UNITED STATES
NUCLEAR REGULATORY COMMISSION
WASHINGTON, D. C. 20555

Dockets Nos. 50-313
and 50-368

Amendment No. 47
License No. DPR-51

Amendment No. 17
License No. NPF-6

Figure 6.2-2 Functional Organization for Plant Operation

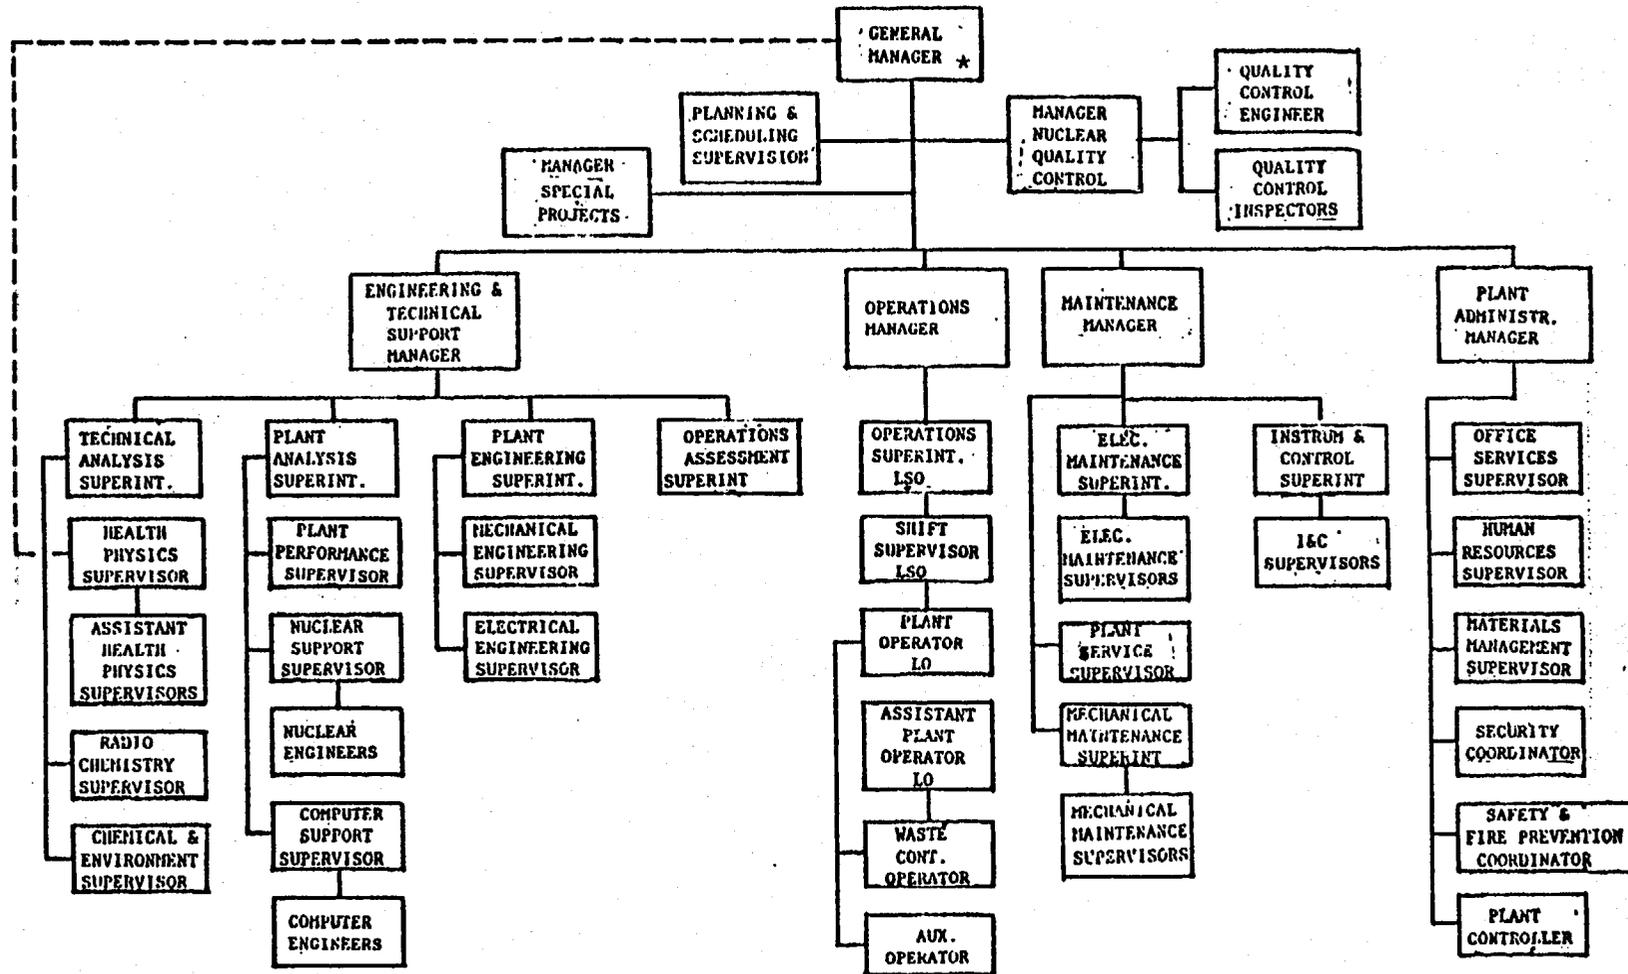
These amendments modify the ANO-1&2 Appendix A and Appendix B Technical Specifications dealing with the Arkansas Power & Light Company management organizational structure.

We have reviewed and discussed with the AP&L staff the proposed changes to the ANO-1&2 Administrative Control Sections of the TS. We have made modifications to the proposed changes which have been agreed to by the AP&L staff. The position of Director, Generation Operations would be divided into Director, Fossil Operations and Director, Nuclear Operations to provide improved management resources to nuclear operations.

The membership of the Plant Safety Committee (PSC) would be revised, resulting in a net gain of at least two members. In addition, the new position of Manager of Special Projects would be the Chairman of the PSC.
